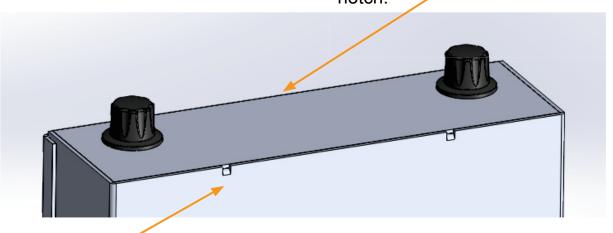
can this edge be overbent slightly to improve fit? the face will then squeeze the notch.

notch is intended to support case wall.

can the notch be formed on the turret punch?
